DEL PUERTO CANYON **RESERVOIR**

Environmental Impact Report Volume V-Response to Comments on PRDEIR

SCH# 2019060254

Prepared for:
Del Puerto Water District
17840 Ward Avenue/P.O. Box 1596
Patterson, CA 95363

Figure 12-1 San Joaquin River Floodplain at the Del Puerto Creek Confluence

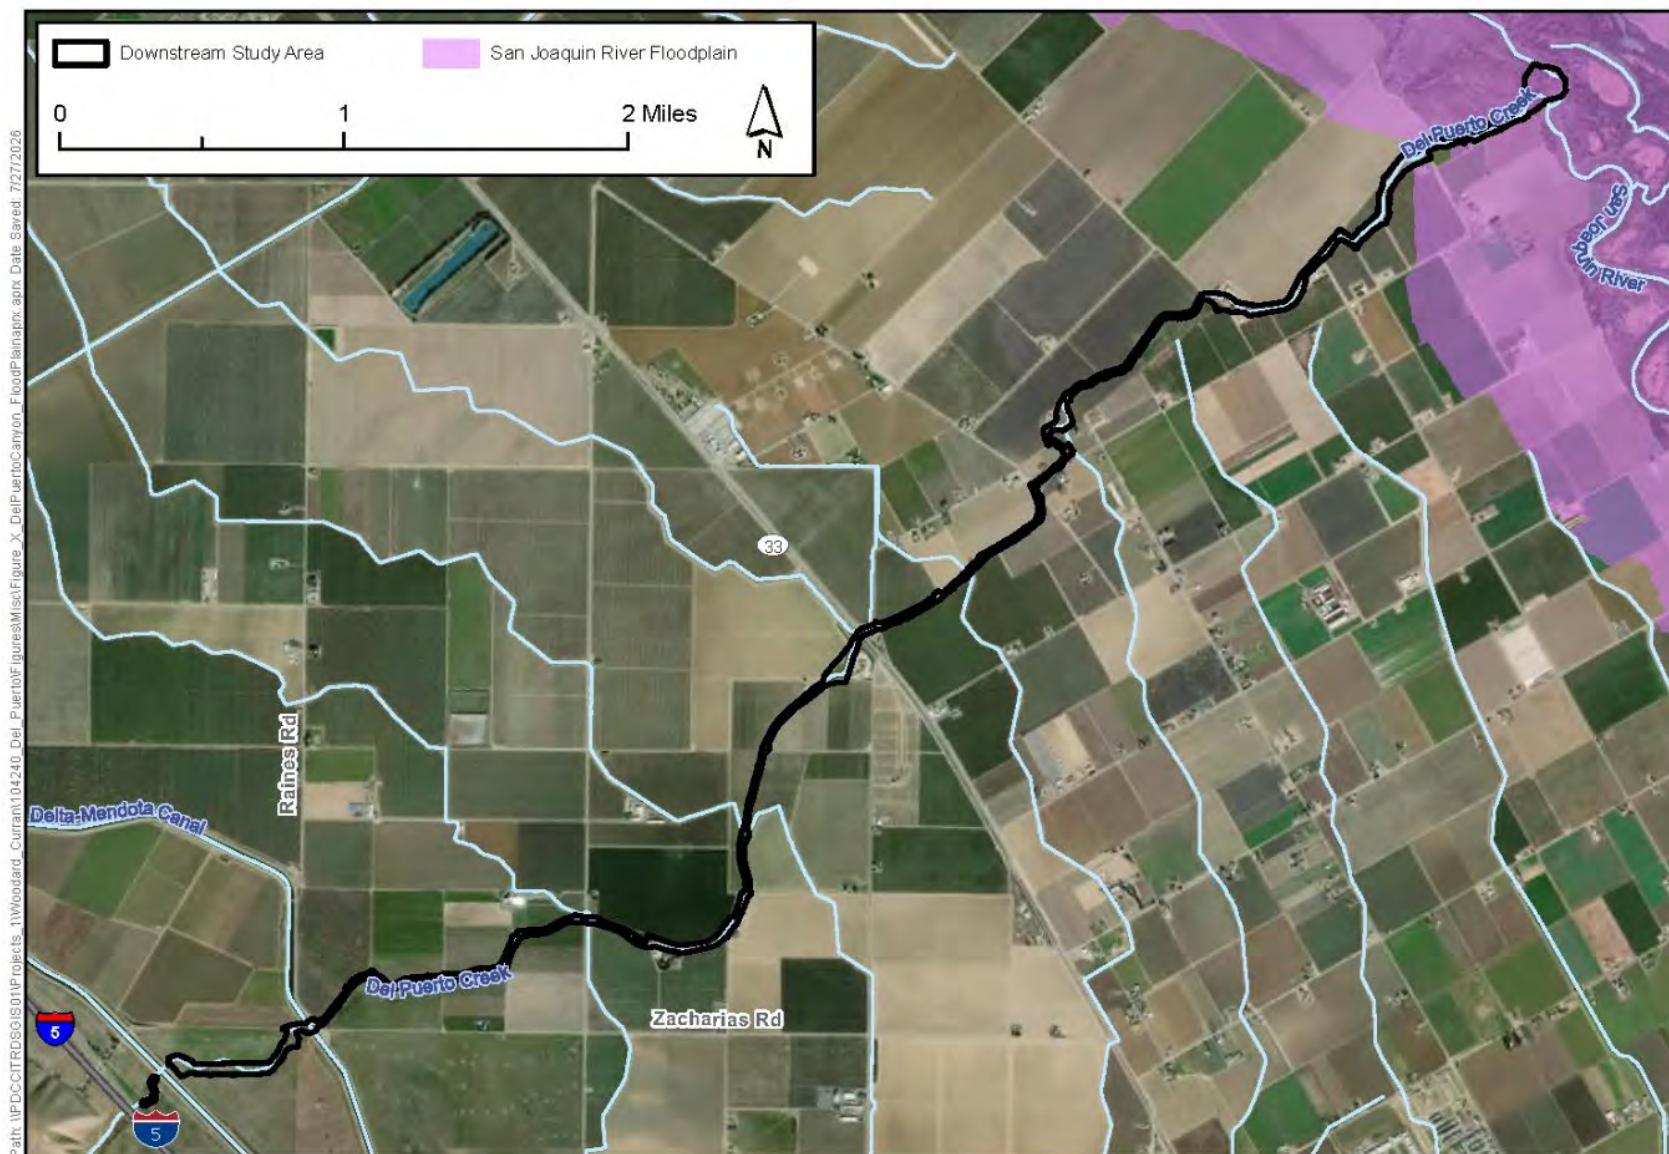
Comment Summary: Several commenters questioned how downstream ecological processes supporting downstream terrestrial resources would be retained despite reduced total flow volume.

Figure 12-1 illustrates the extent of the San Joaquin River floodplain (shown in purple) at its confluence with Del Puerto Creek. Near the confluence, the broader riparian corridor along Del Puerto Creek lies within the San Joaquin River floodplain. In contrast, the majority of Del Puerto Creek in the downstream study area is located outside of the San Joaquin River floodplain, and is characterized by a narrow, fragmented riparian corridor surrounded by intensive agricultural development and associated residences.

The Project would not materially alter the San Joaquin River setting. Appendix F estimates that Project-related changes in average monthly San Joaquin River flow at Vernalis would be less than one percent and would not appreciably change river or Delta flow conditions. Accordingly, the more persistent hydrologic conditions, developed riparian vegetation, and regional connectivity documented near the confluence would remain under Project conditions.

Figure 12-2: Foothill Yellow-legged Frog Proposed Critical Habitat

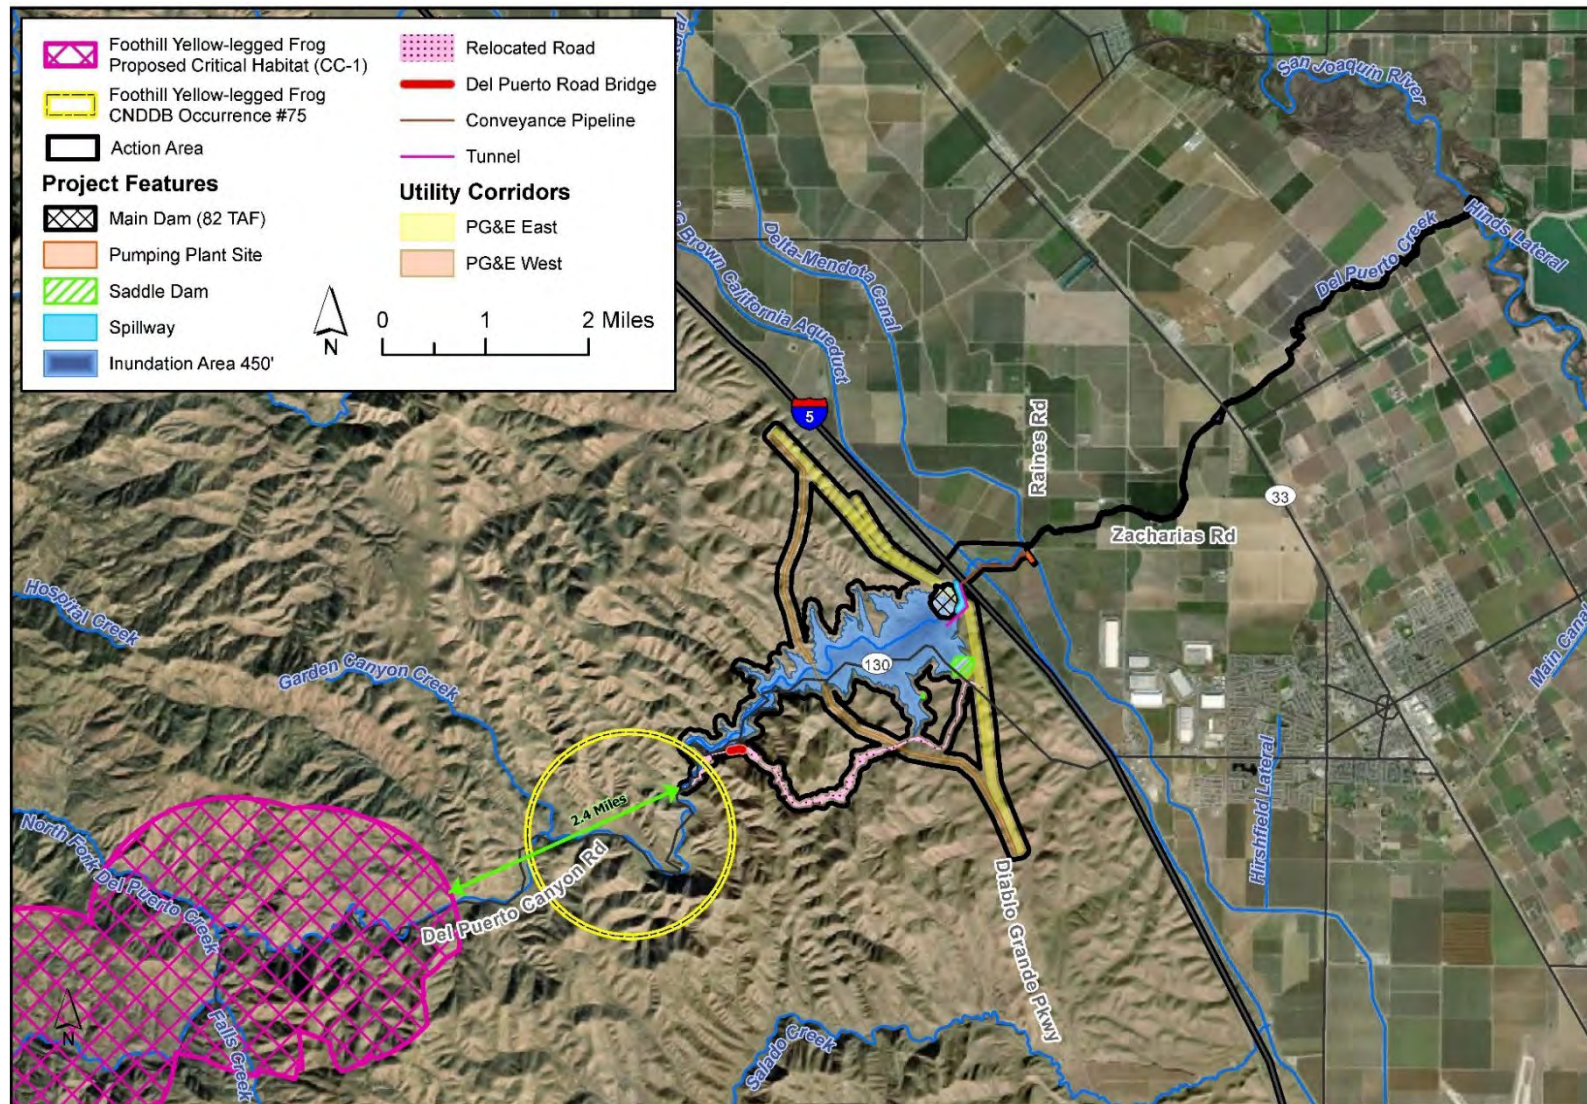
The comment also references the U.S. Fish and Wildlife Service's (USFWS) January 2025 proposed critical habitat designation for four distinct population segments of foothill yellow-legged frog. The proposal includes a Del Puerto Creek subunit in the upper watershed, predominantly within Santa Clara County. However, the proposed subunit is approximately 2.4 miles from the original study area and approximately 5 miles southwest of the downstream study area, as depicted in **Figure 12-1** below.

Nor does the proposed critical-habitat rule establish a new effect within downstream study area. A proposed critical-habitat designation identifies areas considered important to the species' conservation for purposes of the federal Endangered Species Act. It does not, by itself, establish species occupancy or suitable habitat at every location within or near a proposed unit. The PRDEIR's conclusions regarding foothill yellow-legged frog are based on the site-specific habitat conditions, occurrence records, and impact pathways present within the downstream study area.

Accordingly, the proposed critical habitat designation does not constitute significant new information requiring preparation of a subsequent or supplemental EIR or further recirculation. It does not reveal a new significant impact, a substantial increase in the severity of a previously disclosed impact, or a feasible mitigation measure or alternative that the District declined to adopt (See CEQA Guidelines, §§ 15162–15163, 15088.5, subd. (a)). At most, it provides updated regulatory and conservation context for species and habitat that the 2020 EIR already evaluated. It does not alter the 2020 Final EIR's or the PRDEIR's impact analyses or conclusions regarding potential impacts to foothill yellow-legged frog. The proposed rule does not demonstrate that the Project would cause an environmental impact different from or more severe than those previously identified.
